AMENDMENTS TO THE DRAWINGS

REMARKS/ARGUMENTS

Fig. 1

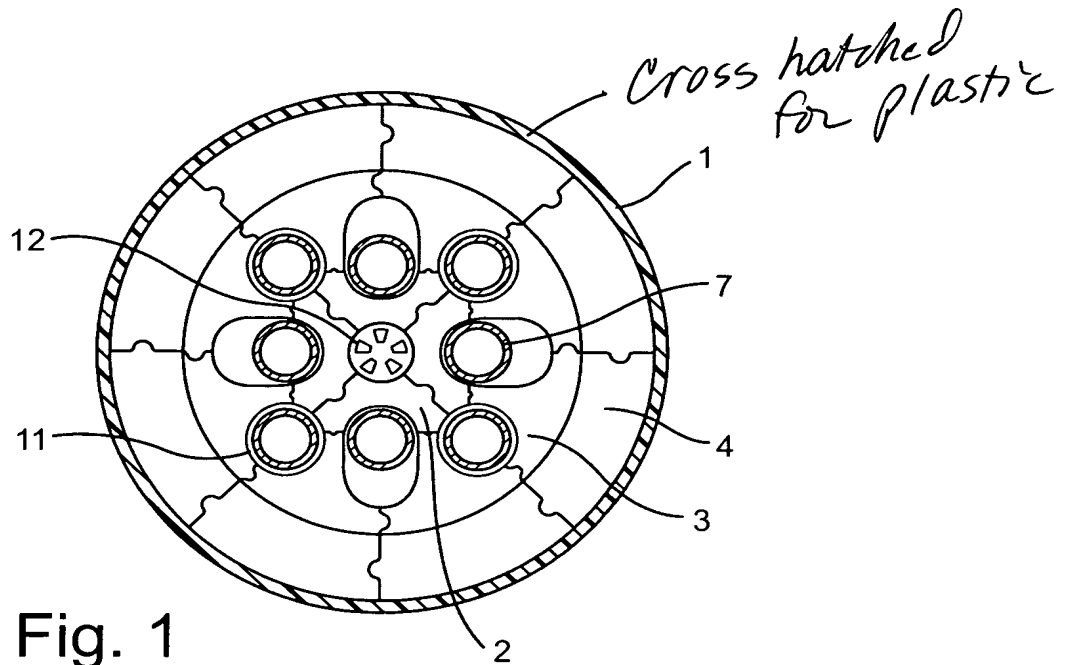
The drawings were objected to because Figures 1-3 lacked proper cross-hatching indicating the types of materials. In particular, the Examiner indicated that the cross-hatching to indicate the conductor and insulation materials is improper. At the outset, it is respectfully noted that the cross-sectional illustrations provided by applicant are consistent with that provided, e.g., in the primary reference cited against the claims, Haug (USP 5,813,106). Furthermore, the cross-hatching provided, for example, for electric conductor 8 and pipe 7 is not only consistent with the applied art but proper because the simple cross-hatching used therefore is proper for cross-hatching of a non-descript, unidentified material. It is noted that while the pipes 7 and electrical conduits 8 are well known in the art, as mentioned the specification, the particular material thereof is not described and is not critical to the invention disclosed herein.

In view of the Examiner's comments during the interview, the corrected drawing submitted herewith corrects the cross-hatching for the outer sheath 1 to be plastic and central fluid flow line 5 to be plastic as disclosed. The filter material 2,3,4,6, and 9 is disclosed as being plastic but following the telephone interview with the Examiner it is

understood that it is acceptable for those parts not to be cross-hatched because this will detract from a review of the illustration and because conventionally in this art filler material is not cross-hatched in cross-sectional views. The simple single line cross-hatching has been maintained for conduit 7 and 8 consistent with the fact that the material of these tubes is not critical but to show that in fact a structure is present rather than a hollow space. It is believed that the revised drawings are consistent with the disclosure, consistent with the illustrations typically provided in this area of technology and are therefore proper.
